BAR Meeting
February 15, 2017

ISSUE: Permit to Demolish and Certificate of Appropriateness for Alterations

LOCATION: 106 North Lee Street

BAR2017-00020 & 00021

Figure 1: Proposed south elevation with sightlines (highlighted in red) which show the change in grade from Ramsay Alley to North Lee Street; the pyramidal skylight will not be visible.

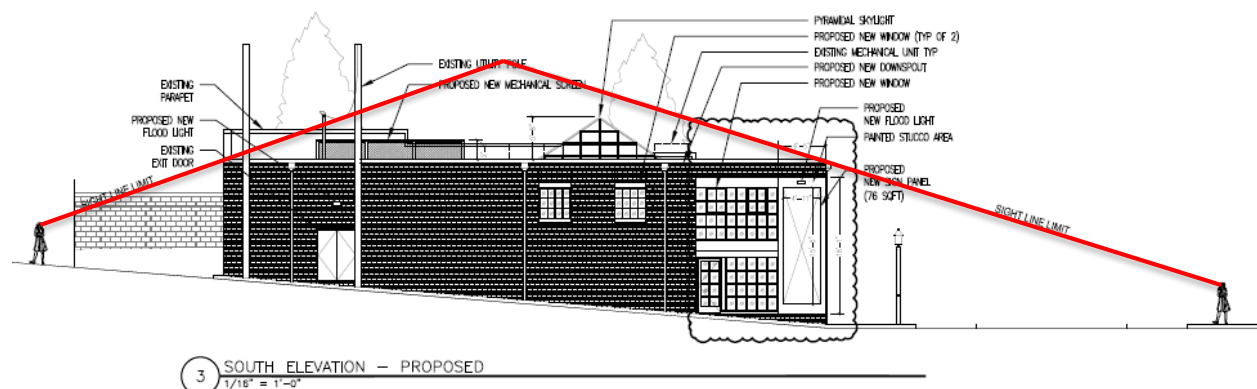
The architect asserts that the pyramidal skylight (manufactured by Super Sky Products Enterprises, LLC) will not be seen from any public right-of-way [Figures 1 and 2]. It, therefore, does not fall under BAR review and will not be considered as a part of the Certificate of Appropriateness. Similarly, staff believes that the 12 Wasco-brand, Thermalized Skydomes will not be visible from any public right-of-way, obscured by the existing parapets as well as by their positions on the flat roof, and therefore cannot be considered in this discussion.

Figure 8: Proposed east elevation.

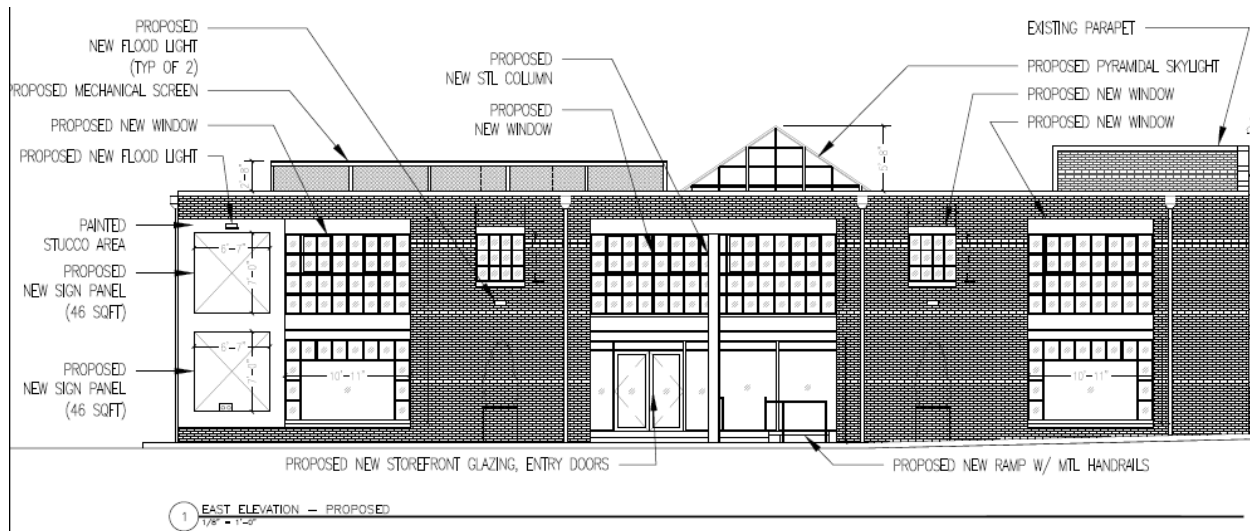
The façade is divided visually into eight structural bays, in which the second, fourth, fifth, and seventh bays are glazed. Currently, the façade sports two large plate-glass, storefront windows flanked by two-light sidelights and one-light transoms on the second and seventh bays. The applicant wishes to demolish a 49-square-foot area above each window in order to enlarge the apertures, creating fenestration that spans the two floors (17-feet and nine inches high by ten feet and 11 inches wide). The new apertures will hold multi-light, fixed windows (portions of which have two operable, outward-projecting casements) on the second floor and fixed, plate-glass storefront windows surrounded on three sides by multi-light panes on the first floor. Similarly, the centralized entrance (in the fourth and fifth bays) now holds a large, multi-light transom that the applicant wishes to replace with a large expanse of glass on the upper floor: another multi-light, fixed window with four operable casements that will match those flanking it. This will require demolishing 96 square feet above of fabric the upper threshold of the transoms to enlarge the current aperture. Finally, the applicant proposes to remove the three existing awnings currently installed above the four fenestrated bays in order to give unobstructed views of the new curtain walls.

In addition, the applicant wishes to demolish a further 44 square feet of building material on the second floor (in the third and sixth bays) in order to install two, 22-square-foot, multi-light fixed windows between the two end curtain walls and the central entrance. The proposed replacement windows are “heavy commercial,” EFCO, Series 550-I (Project-Out) Thermal, Architectural Grade Projected Flush-Face windows which are double-glazed, with aluminum frames field painted black. The applicant must ensure that the windows meet the *Alexandria Replacement Window Performance Specifications*, in that “multi-light insulated glass windows must have permanently fixed muntins on both the interior and exterior, with spacer bars between the glass that are a non-reflective, medium value color.” Staff draws attention to this detail because the manufacturer’s specifications sheets provided suggest the “windows are inside glazed with an extruded aluminum snap-in glazing bead,” and BAR praxis has been to not support sandwich or snap-in muntins because portions tend to fall off over time. In addition, the *Alexandria Replacement Window Performance Specifications* state that “all glazing must be clear, non-reflective and without tint;” staff singles out this detail because, while the provided specifications

meet the 72% lower threshold of visible light transmission (VLT), they do not meet the through-the-glass shading coefficient between .87-1.0 (at .63) nor do they meet the reflectance standard or less than 10% (at 12% exterior and 13% interior). Staff supports the proposed aluminum storefront windows provided that the muntins be permanently affixed and that the glazing meet the BAR's requirements for value light transmission.

Alterations to the entrance entail squaring off the current angled entry vestibule by removing the storefront windows on the southwest wall and adding new storefront glazing. The rectangular entry porch will hold a liminal entry vestibule with two successive pairs of new, outward-swinging, full-glass, double doors. The recessed entry porch will be bifurcated by a new steel, non-structural column; on the north side of the column, the applicant proposes to install a new, U-shaped handicap ramp with simple metal handrails. Furthermore, the angled stairs that currently exist within the covered porch will be demolished and replaced by a raised platform, access by new stairs (two risers) aligned with the exterior wall. Manufacturer's specifications for the doors should be provided to BAR staff and the glazing should meet the value light transmission requirements as specified in *Alexandria Replacement Window Performance Specifications*.

Further details include the addition of three new exterior light fixtures: two below the proposed new windows on the third and sixth bays, which flank the entrance, and one above the proposed wall signage on the first bay. The applicant has supplied manufacturer's specifications for LED Flood Luminaire, D-Series, Size 2 (12-7/8"W x 7-3/4"H [12"OH] x 3-1/8"D) and for LED Flood Luminaire, D-Series, Size 3 (13"W x 13-5/8"H [17-1/2"OH] x 5"D); both are black, which match the window frames and other proposed architectural details. It is unclear, without a light schedule, to know which floodlight is proposed for which location, but staff supports the applicant's decision to choose models with upper/bottom visors to limit the extent of illumination. Because, in general, the BAR is concerned with the *intensity* of exterior lighting (and as per the *BAR Design Guidelines*), the applicant should ensure that "the color of the [luminescence is] appropriate to the architectural character of the building" as well meeting the requirements of the Virginia Uniform Statewide Building Code and the regulations of the local zoning ordinance. While fully supporting pedestrian safety and visibility of this commercial establishment from King Street, staff recommends review of the intensity of this lighting after installation to insure that it is not out of character with the streetscape. If it is not, the lumens must be reduced.

Lastly, the applicant wishes to plaster 168 square feet on the southeast corner (first bay) in order to paint two new sign panels equaling 92 square feet in the future. The commercial-grade, Quikrete Stucco will be applied in a base and finish coat and painted black. Within this field, two primary-colored panels will be painted, within which text advertising the future occupants will presumably be painted. Although it is general BAR praxis not to support the application of paint or stucco to previously unpainted or un-clad masonry, in this case, BAR staff supports the alteration to this Mid-Century warehouse construction where the brick has already been painted. Because the signage portion is in a conceptual phase, the applicant is asking the BAR to approve the sign area with final approval of specific design within the painted stucco areas to be approved by BAR staff administratively at a future date, in accordance with the BAR's sign policy.

Staff recommends approval of the application with the following conditions:

1. All new windows must meet applicable criteria in the *Alexandria Replacement Window Performance Specifications* (contained in the BAR's adopted window policy):

- a. Multi-light insulated glass windows must have permanently fixed muntins on both interior and exterior.
 - b. All glazing must be clear, non-reflective, and without tint;

- i. through-the-glass shading coefficient must be between 0.87-1.0.
 - ii. the reflectance must be less than 10%.
2. All new and replacement doors and trim must comply with adopted BAR policies.

Figure 7: Revised proposed south elevation

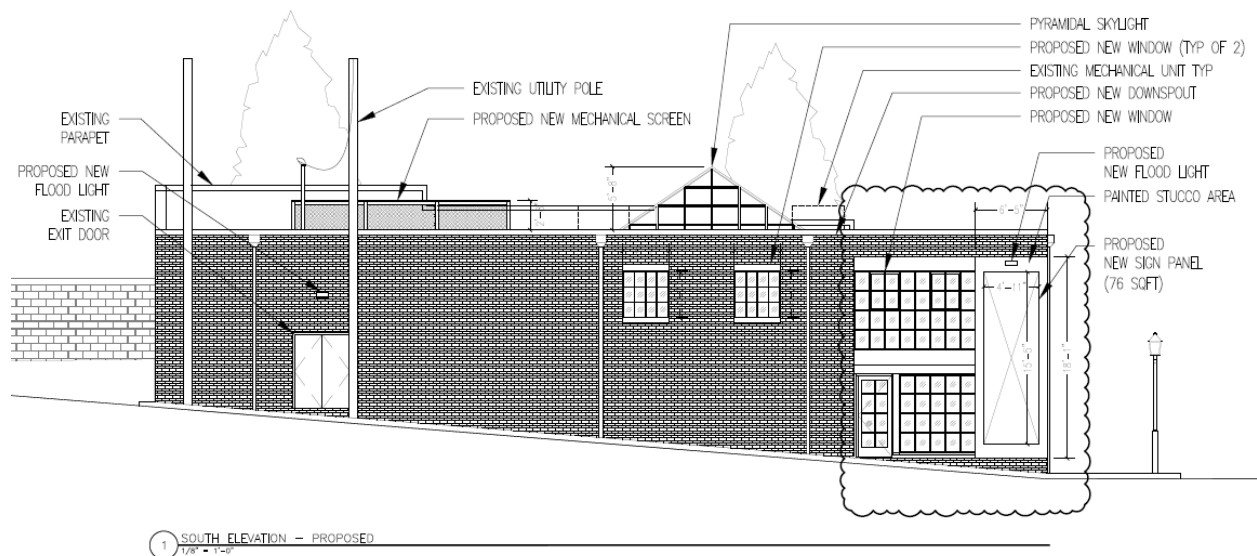
The majority of alterations proposed for this seven-bay side are focused primarily on the southeast corner, on bays four through seven, and entail adding a series of windows to an almost-blind wall [Figure 7]. Most significantly, the applicant proposes to create a curtain wall by installing a multi-light, fixed window with two operable casements on the second floor equivalent to those on the façade, as well as a multi-light, fixed window on the first floor. Since his first submission, the applicant has revised his drawings: whereas he had a storefront window surrounded on three sides with multi-light panes (like those on the façade) on the first floor, now he requests a fixed multi-light window and a multi-light door. In addition, the applicant wishes to install two new fixed, multi-light windows on the second floor just west of the curtain wall (the fourth and fifth bays). They are similar in size and style to the two proposed on the façade.

Like on the façade, the applicant wishes to plaster 106 square feet on the southeast corner in order to paint one new sign panel encompassing 76 square feet. The applicant also wishes to install two new exterior lights on this elevation – one above the signage on the seventh bay and one above the existing fire-exit door on the second bay. The applicant also proposes to remove two existing downspouts on the fourth and seventh bays, and replace one by adding a new one to the fifth bay.

1 ROOF PLAN - PROPOSED
3/32" = 1'-0"

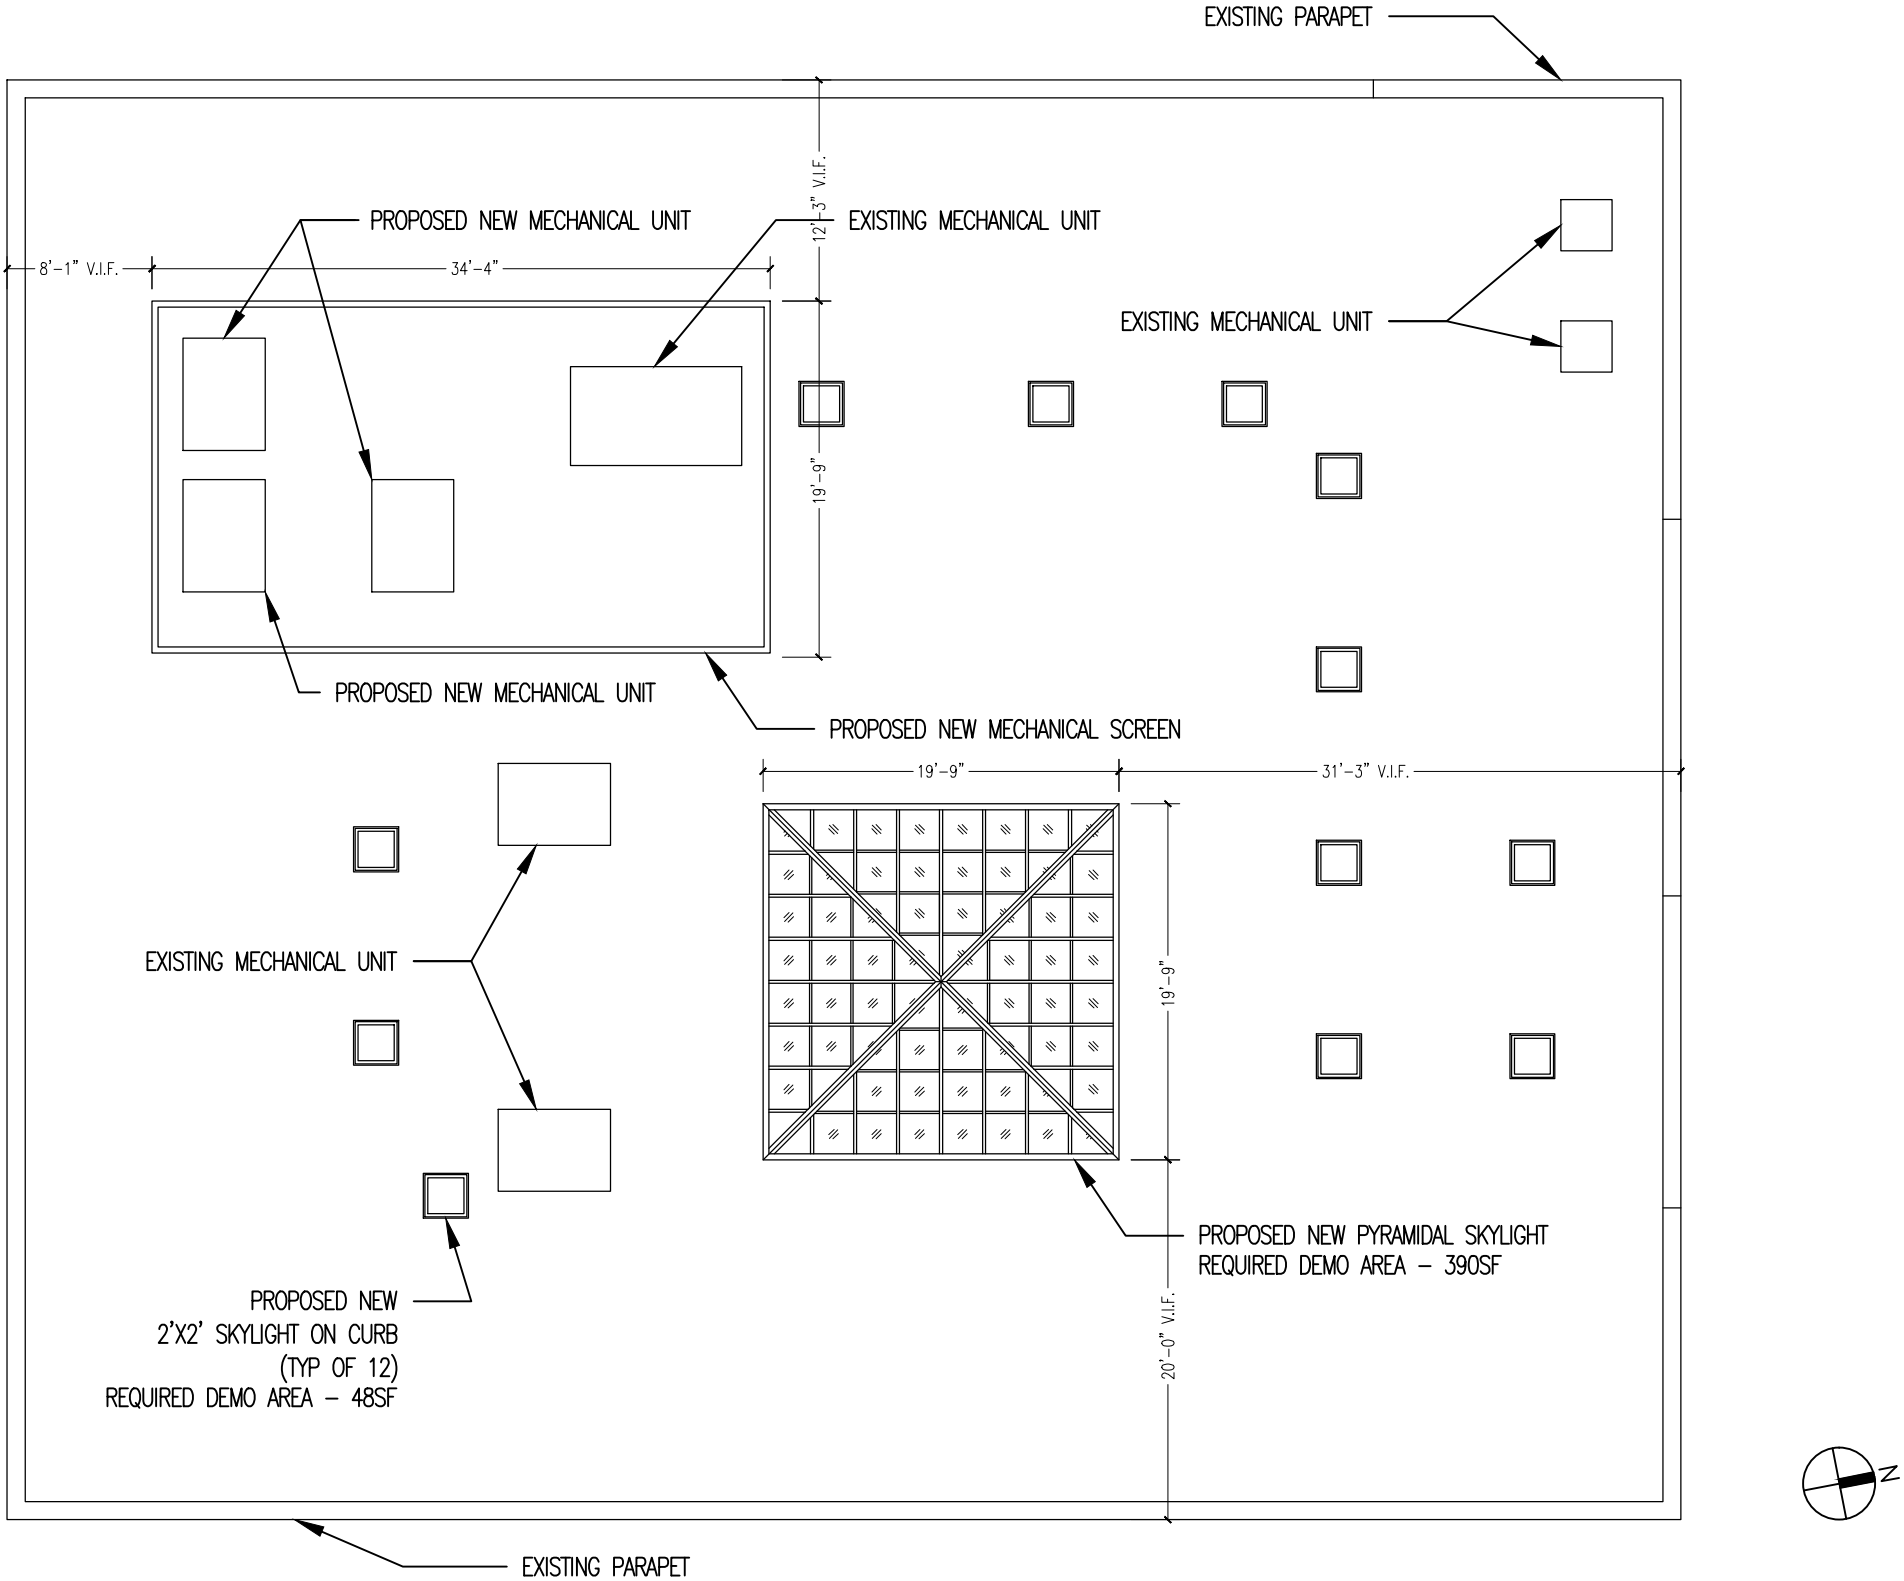
However, as illustrated in Figure 3, a portion of the present HVAC mechanical screening is visible from Ramsay Alley; therefore, any enlargement of the screening will be visible and should be considered as part of the applicant's request. The current screening is a white-painted, wooden lattice in disrepair and not integrated with the existing architecture [Figure 5]. The BAR *Design Guidelines* state that "rooftop HVAC equipment must be screened with architectural materials or features of the same type or quality used on the exterior walls of the building" or that the screening material(s) should be painted to match the adjacent built fabric, although, often, screening on a flat roof is painted white in order to blend in with the palette of the sky,

While it would be extreme to support and construct a masonry parapet to obscure rooftop mechanical equipment, on the spectrum of materials, Victorian period garden lattice is not architecturally appropriate and there should be something more sturdy and durable than wooden lattice which, as Figures 3&7 illustrate, degrades easily if not maintained. Staff notes that the sheet metal mechanical screening on the roof of Virtue Feed and Grain at 106 S Union Street is much more visible and is generally successful. Manufacturer's specifications for the HVAC mechanical screening have not been included in this design submission. Staff, therefore, recommends that the BAR provide specific guidance on architecturally appropriate material and design at the hearing for staff approval of the screening before the building permit is issued.

In addition, the Certificate of Appropriateness addresses the proposed relocation or replacement of two rooftop HVAC mechanical units and the installation of one new rooftop HVAC mechanical unit. Manufacturer's specifications for the new or replacement mechanical units have not been included in this submission and staff notes that the applicant must provide that information to ensure compliance with the zoning ordinance before a permit is released.

3. The applicant must submit the materials and design of rooftop HVAC mechanical screening for staff review prior to release of the building permit to ensure compliance with BAR comments at the hearing.

4. The applicant must submit specifications for the new and replacement HVAC units in order to ensure that they comply with the zoning ordinance.
5. Bricks used for infill must match in color, texture, and size those that currently compose the structure, with final approval by staff.
